Re: Indian Point Units 2 & 3  
Docket Nos. 50-247 & 50-286  
NL-09-018

SUBJECT: Entergy Nuclear Operations Inc.  
Indian Point Nuclear Generating Unit Nos. 2 & 3  
Docket Nos. 50-247 and 50-286  
**Reply to Request for Additional Information – Miscellaneous Items**

IPEC LRA Responses for RAIs and SER Open Items

**INDIAN POINT NUCLEAR GENERATING UNIT NOS. 2 AND 3  
LICENSE RENEWAL APPLICATION  
REQUEST FOR ADDITIONAL INFORMATION (RAI)**

**CONTROL ROD DRIVE HEAD PENETRATION**

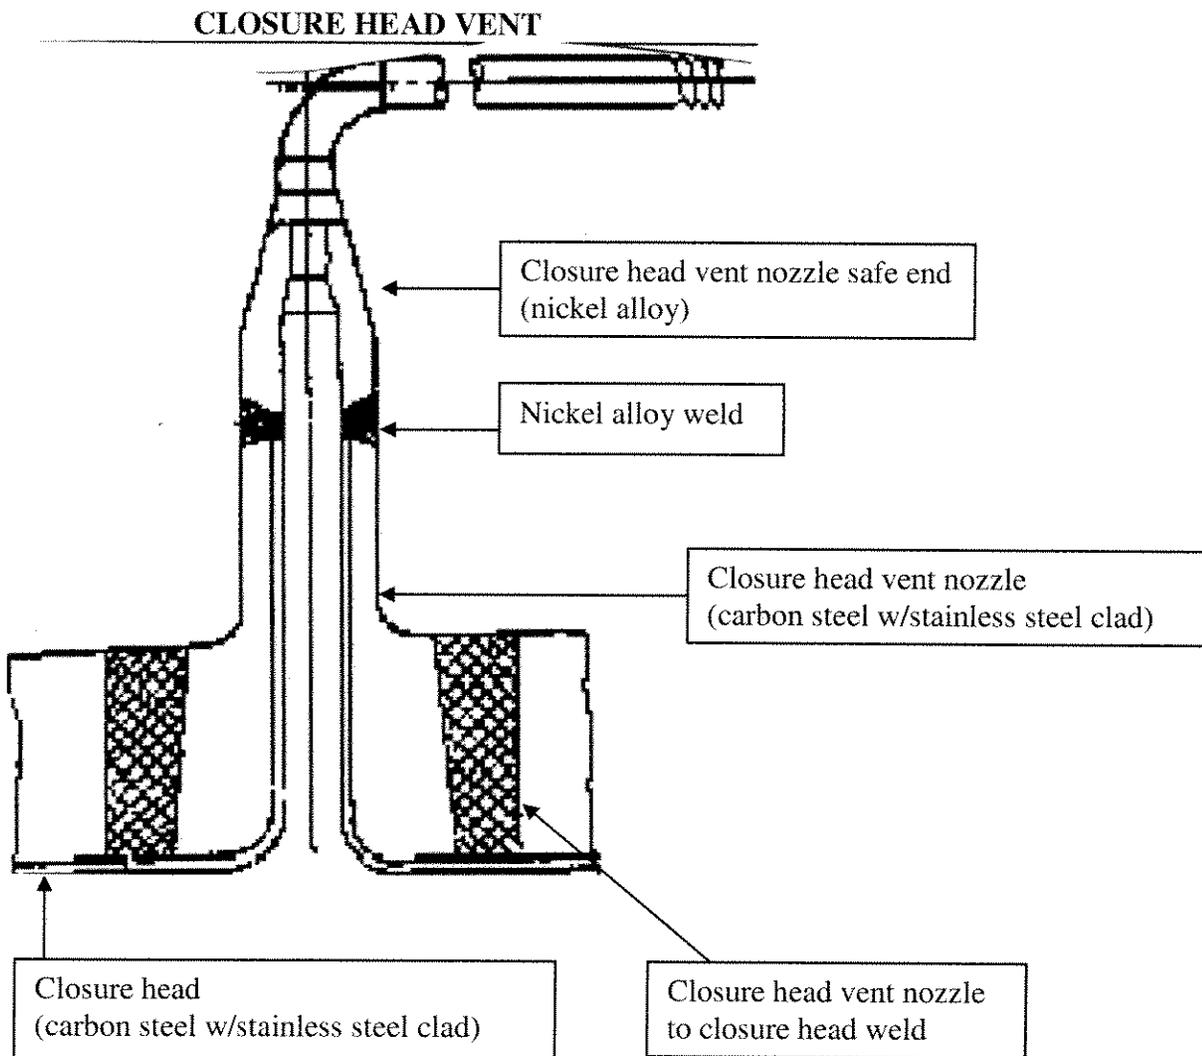
**Part A** - Clarify whether the following components at IP2 or IP3 are fabricated from Alloy 600 base metal materials or welded with Alloy 182 or Alloy 82 filler metal materials: (1) control rod drive (CRD) housing-CRD nozzle welds, (2) upper reactor vessel closure head (RVCH) head vent nozzle-to-RVCH welds, and (3) CRD housing penetration core exit thermocouple nozzle assembly (CETNA™) components.

The reactor vessel closure head CRDM housing tubes (nozzles) for IP2 and IP3 are fabricated from nickel-based alloy. The nozzles penetrate the closure head. These nozzles are attached to the head with partial penetration nickel alloy welds. A stainless steel housing adapter flange is welded to the top of each nozzle. These housing adapter flanges are machined forgings onto which the CRDMs, instrumentation port female flanges, capped latch housings, and head adapter plugs/caps are threaded and seal-welded. The following figure provides details of the penetration.
